CLIMATE
ACTION
RESERVE

SUMMARY OF COMMENTS & RESPONSES DRAFT NITROGEN MANAGEMENT PROJECT PROTOCOL VERSION 1.0

17 sets of comments were received during the public comment period for the Climate Action Reserve (Reserve) draft Nitrogen Management Project Protocol Version 1.0. Staff from the Reserve summarize and provide responses to these comments below.

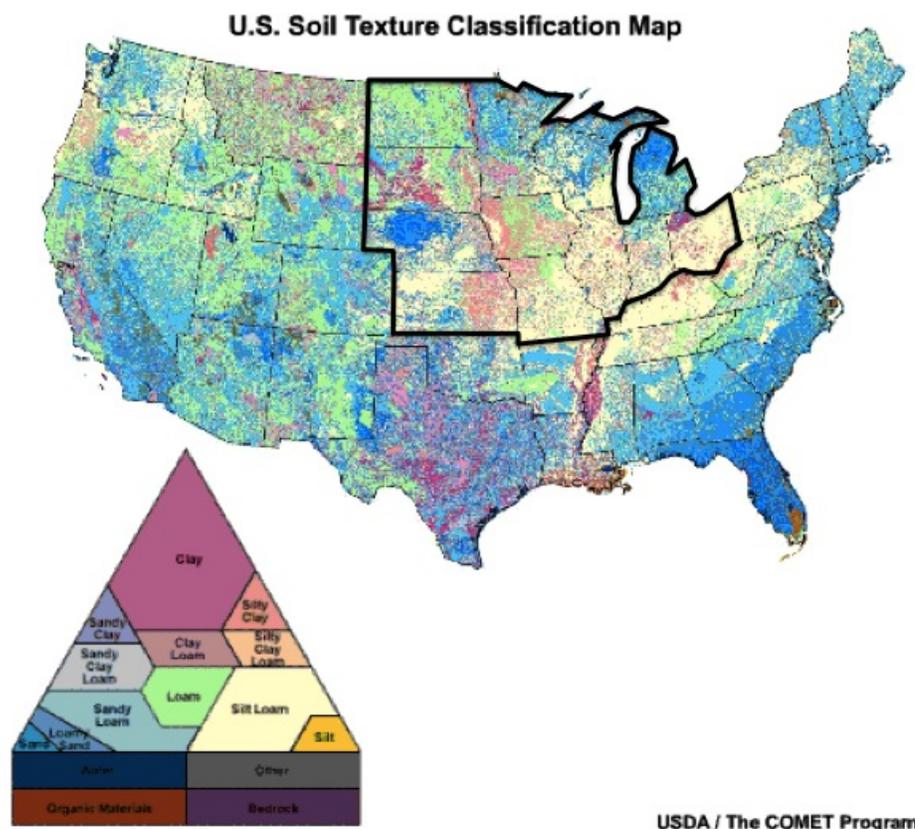
82. The 12 state region represented in the draft protocol varies significantly from the five Michigan field sites where the regression equation was developed. As a result, we do not believe the regression equation used to quantify N₂O emission reductions should be extrapolated that far from the conditions under which it was developed. Doing so misrepresents the potential N₂O emission reductions that can actually be achieved.

Until further field observations are available, the relationship currently used in the CAR draft protocol should be limited to soils within 5-10% of clay content of field sites, to sites that have a 10-year average annual growing season precipitation within 1 standard deviation of the 10-year precipitation average at the study sites, to sites that do not have tile-drainage or irrigation, and to sites where the USDA plant-hardiness index falls within 1 unit of the study sites. In doing so, we aim to ensure that N₂O emission calculations based on this MSU EPRI study are conservative and that they do not overestimate N₂O emission reductions. **[See UCS, Niles, and Tonitto public comment submission for further detail.] (UCS et al., Gambino, NWF et al.)**

RESPONSE: The 12-state region is consistent with the applicability region proposed by the developers of the emission factor used in the NMPP. The developers noted that the emission factor would be applicable in corn systems in the NCR, given the uniformity in agronomic practices in the region, and the robustness of the exponential response of N₂O to N rate across multiple cropping systems and regions. Nevertheless, the Reserve acknowledges that factors such as climate and soil texture can have a great impact on N₂O emissions.
